Luci Duncalf

**APPLICATION NO:** 02/2020/0811/ PF

**PROPOSAL:** Erection of a detached dwelling, construction of a new vehicular access and associated works

**LOCATION:** Land at (Part Garden of) 73A Erw Goch Ruthin LL15 1RS

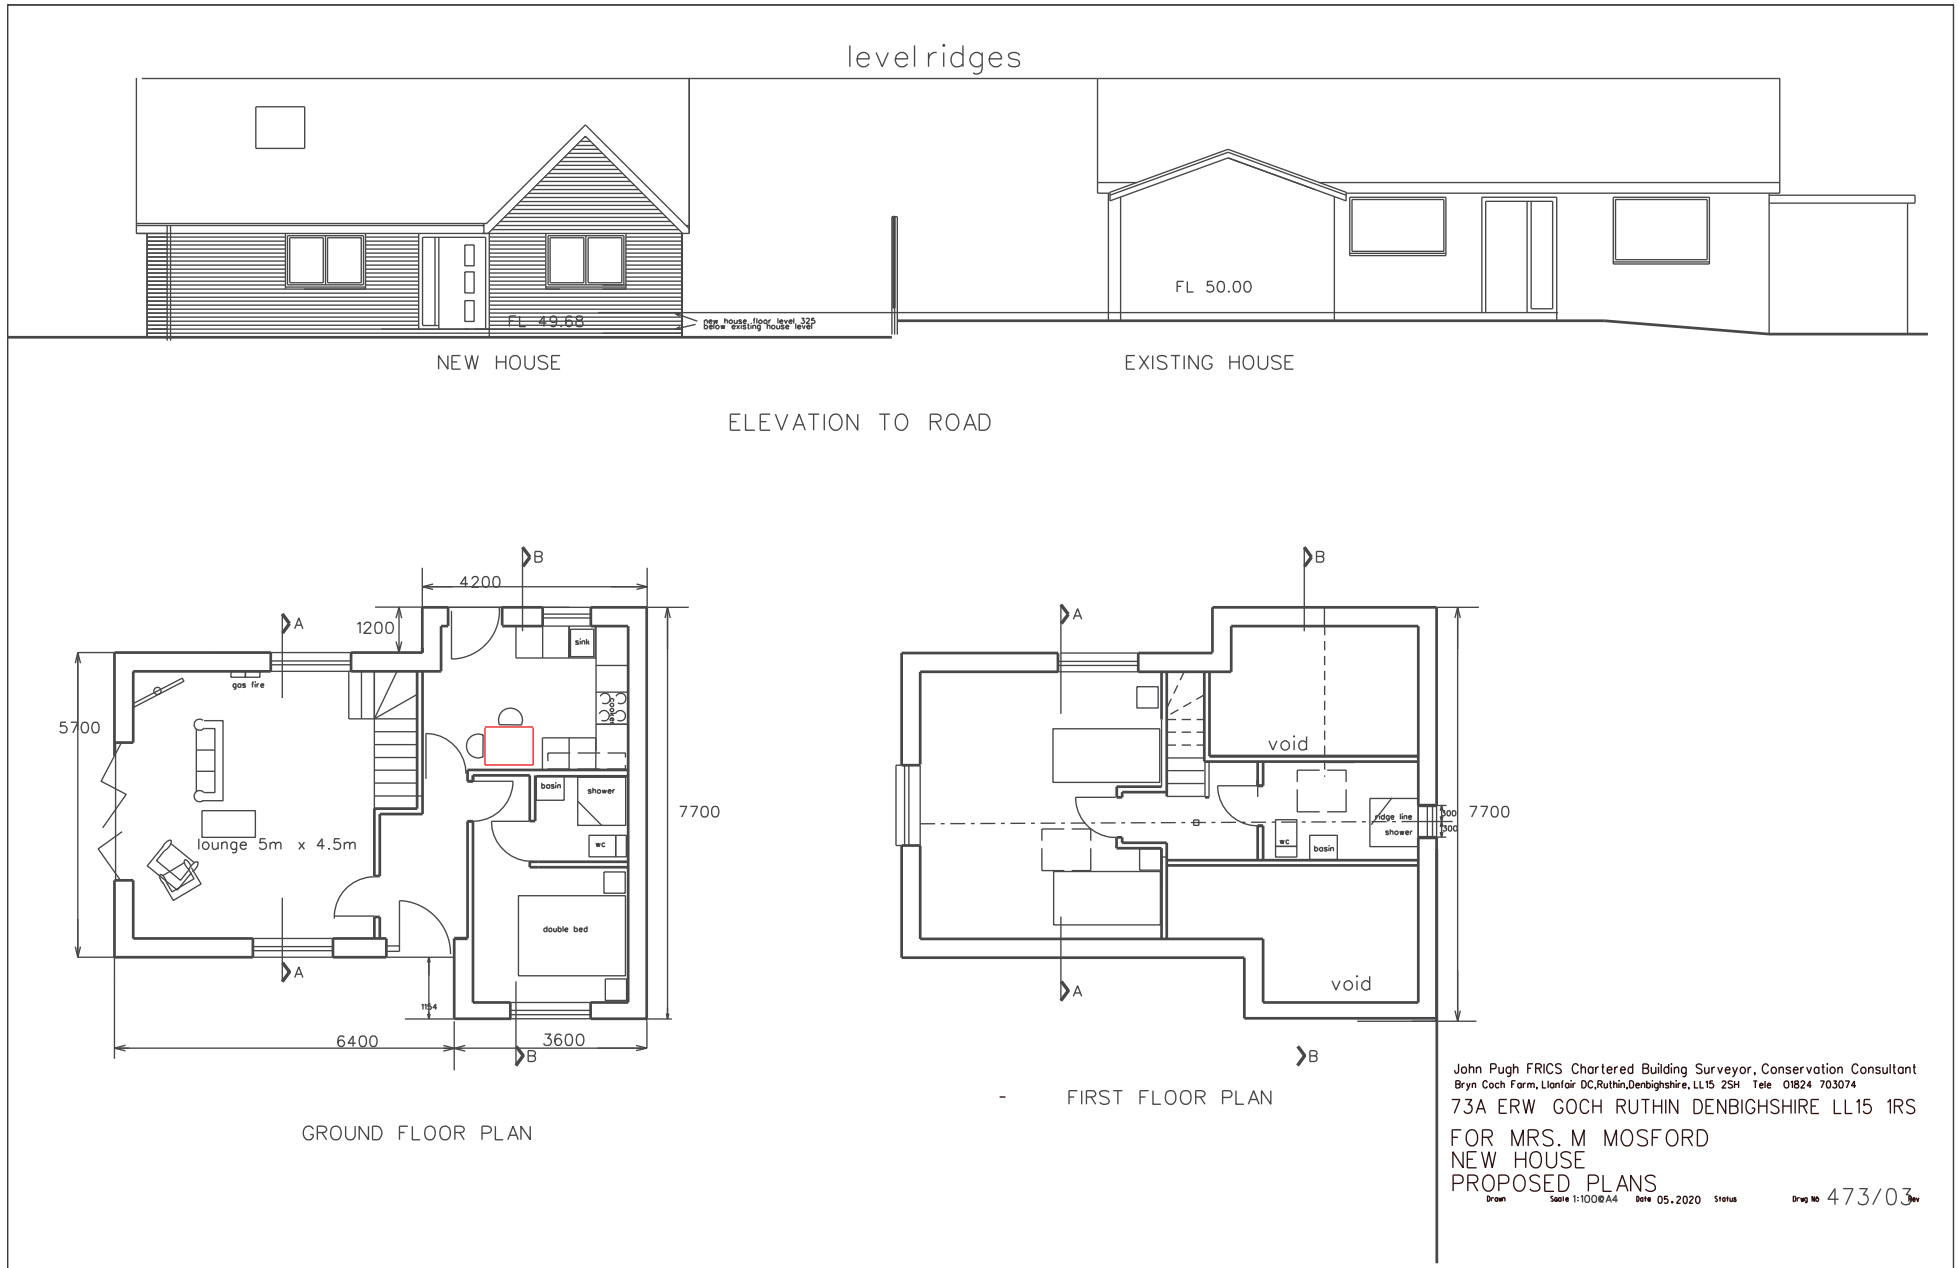
The existing dwellings on this side of the road are all set back from the pavement approximately more than 2.5m. The proposed dwelling would be set back by 1.7m (at its nearest) from the pavement. It is considered that this would lead the development to appear cramped in the plot and out of character with the existing building lines of development in the area.

The proposed front elevation of the new dwelling would be approximately 1.7m at the nearest point from the proposed low boundary wall to the front of the dwelling to separate the pavement from the site. The Erw Goch Estate is characterised by dwellings which are set back from the road and enjoy amenity space and parking to the front which adds to the visual amenity and character of the area. It is considered that the front elevation would be too close to the boundary and would detract from the open fronted nature and the general built form of the estate.

With regard to the impact on the nearest neighbouring bungalow, Duinrell, there would be a separation distance of 8m between the side elevation of the proposed dwelling and the side elevation of the existing bungalow, separated by a fence down the boundary line. The side elevation of Duinrell has the only available lounge window which serves a habitable room which would, as a result of the development face out onto a small strip of garden area of just 4m in depth and onto the side elevation of the new dwelling at total of 8m away. The Residential Development SPG states that '*where a wall containing*

It is therefore considered that given the short distance between the habitable lounge window and the side elevation of the proposed dwelling, that the distance should be 15m minimum in line with advice contained in the Residential Development SPG and just 8m in distance would result in an unacceptable impact to the residential amenity of the occupiers of Duinrell.

*View of proposed dwelling heading down Erw Goch towards Ruthin.*

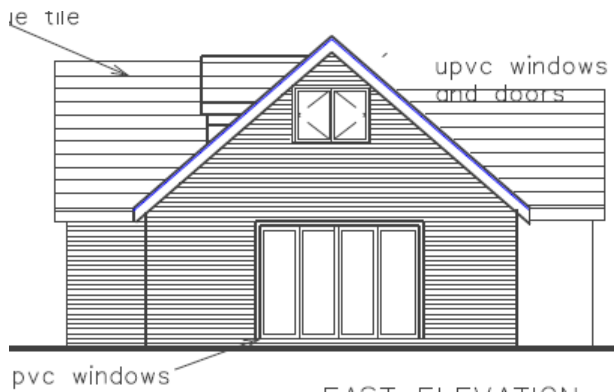
However, having regard to visual amenity, it is considered that the site is a relatively small triangular parcel of land which was never intended to be developed and was to be incorporated into the garden area of the bungalow adjacent. The corner point of the plot is in a prominent location on Erw Goch with a Public Right of Way to the rear side and the pavement to the front side. The proposed dwelling would be the first in a row of 5 similar style bungalows. The proposed dwelling would have a ridge height of 4.67m which, the Agent has confirmed, is level with the ridge on the adjacent bungalow. However, Officers consider, given the slope of the land, that the side gable would be a prominent, obtrusive feature in the streetscene and would appear out of context and would impact negatively on the visual amenity of the area causing detrimental harm to the character of the area.
